MODIFICATION TO THE B89A

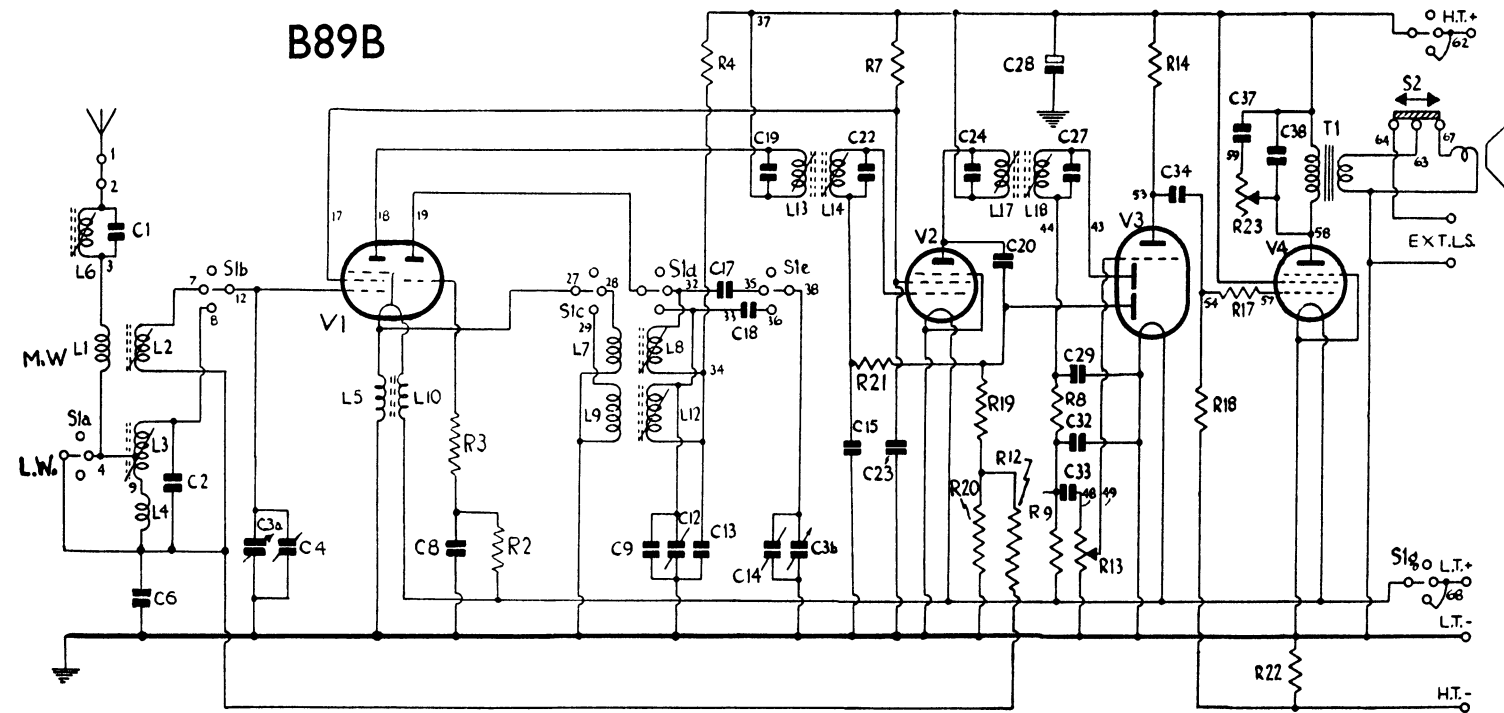
To make oscillation more reliable on the medium waveband, with reduced H.T. voltage, decoupling has been introduced in the primary circuit of the first I.F. transformer.

This consists of a 10,000 ohms resistance between HT+ and L13, with a .01 μF condenser connected from the junction of L13 and the resistance, to V1 filament negative.

- (1) Connect a 10,000 ohms resistance from HT+ (second tag on resistance rack) to the blank socket on V1 valve holder;
- (2) Transfer the pink lead from the 1st I.F. transformer from HT+ to this socket;
- (3) Connect a .01 mfd condenser between this socket and the negative filament socket of V1 valve holder. (The filament socket close to the small resistance panel.)
